RE: 360-378 WINDSOR ROAD, BAULKHAM HILLS ADDENDUM TRAFFIC ASSESSMENT

As requested, please find herein The Transport Planning Partnership (TTPP) addendum traffic assessment for the above proposed development.

Figure 2: Warrants for Left Turn Treatments on Major Road (Design Speed < 100 km/h)

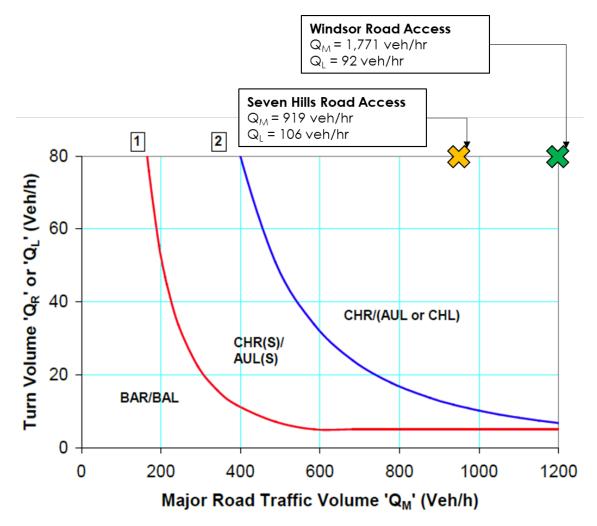
- Roads and Maritime requires that all future vehicular accesses to the proposed development on Seven Hills Road and Windsor Road be restricted to provide for left-in and left-out traffic movements only. A left-turn deceleration lane may be required to facilitate safe and efficient access into the site, in accordance with Austroads warrants and design requirements.

The assessment indicates that both access points meet the warrant for auxiliary left turn (AUL) or channelised left turn (CHL).

However, Austroads recommends that a channelised left turn treatment be provided at unsignalised intersections for safety reasons. A channelised left turn provides a clear line of sign for vehicles turning from the minor road.
